**TOWN OF WILLISTON
DEVELOPMENT REVIEW BOARD
July 9, 2024, 7:00 PM
Town Hall Meeting Room | 7900 Williston
Road**

Minutes approved August 13, 2024 as written.

Figure 1. Blue = existing slate. Orange = existing shingles.

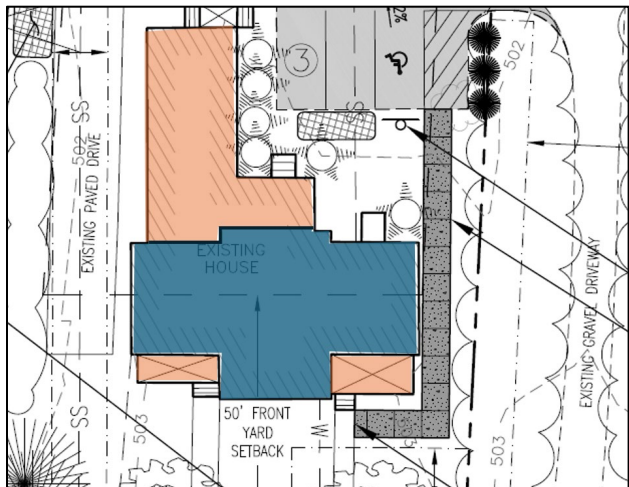
1. Bylaw Requirement per WDB Appendix H Alterations and Renovations, "*Do not obscure original materials, "Respect the original character and period of the building, structure or landmark... Do not try to modernize the architectural features of a building, structure or landmark."*
2. The proposed material [~~does~~ or does not] respect the original character of the c. 1849 structure.

1. Slate roof shall be replaced with slate.

WDB 26

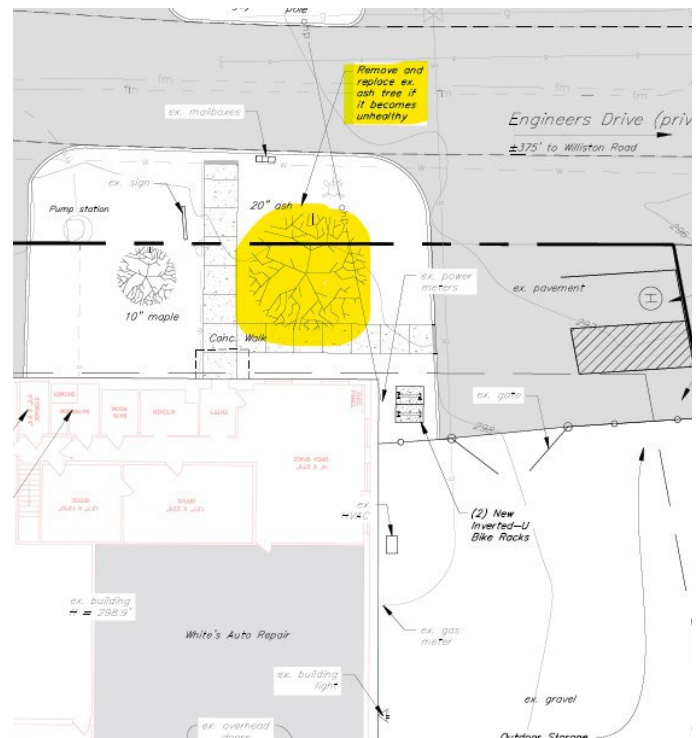
Additionally, Ken Pidgeon had comments about the ash tree replacement, as they would prefer not to remove the tree because at the moment it looks healthy. Pete K. trusts that Ken P. would remove the tree, but generally, there is not the staff power to ensure that the trees are replaced when they die. Therefore, the DRB would be setting a precedent in allowing the tree to remain at risk of disease.

Compliance anticipated. WDB 26.11.2 requires street trees along the existing road frontage of redevelopment projects. The site has 2 existing trees along the existing 270' of frontage where 6 trees would normally be required. One of the existing trees is an ash tree.

The DRB recommended that additional street trees should not be provided along Engineers Drive but recommended that the existing ash tree should be removed and replaced with a different species due to the threat of the Emerald Ash Borer. The applicant has not proposed additional street trees and has stated that "the existing ash tree will be removed and replaced if it becomes unhealthy due to the Emerald Ash Borer."

The applicant shall replace the existing ash tree with a new street tree. Final plans shall include detail demonstrating compliance with WDB 26.4. See Condition 22.

22. **Two (2) street trees shall be maintained in front of 99 Engineers Drive.**
23. **The applicant shall delineate the Class II wetland using boulders or concrete blocks on the ground and on final plans.**

Image below: Pink line shows edge of Class II wetland along the eastern property line.

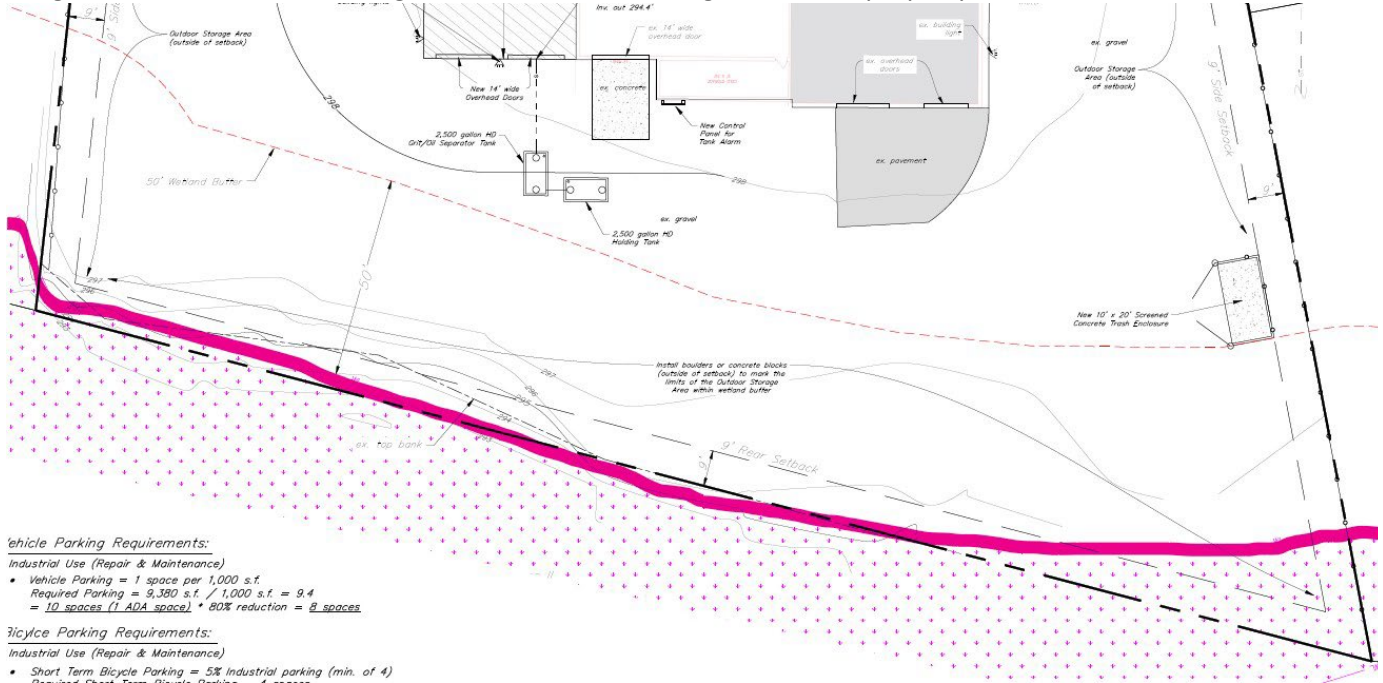
The applicant has submitted a site plan which delineates a Class II wetland and its associated 50' watershed protection buffer along the extent of the eastern property line. The parcel has historically had outdoor storage within the watershed protection buffer and possibly within the mapped wetland.

WDB 29.9.9.2 allows nonconformities located in watershed protection buffers to be maintained, repaired, replaced and enlarged provided that the degree of nonconformity is not increased. WDB 29.9.7 requires that watershed protection buffers are marked on Final Plans and on the ground. The applicant has proposed outdoor storage within the 50' watershed protection buffer and has moved the proposed dumpster enclosure and snow storage out of the buffer. **Outdoor storage in the watershed buffer may continue, however the edge of the Class II wetland must be marked with boulders or concrete blocks on the ground and on final plans. See Condition 23.**
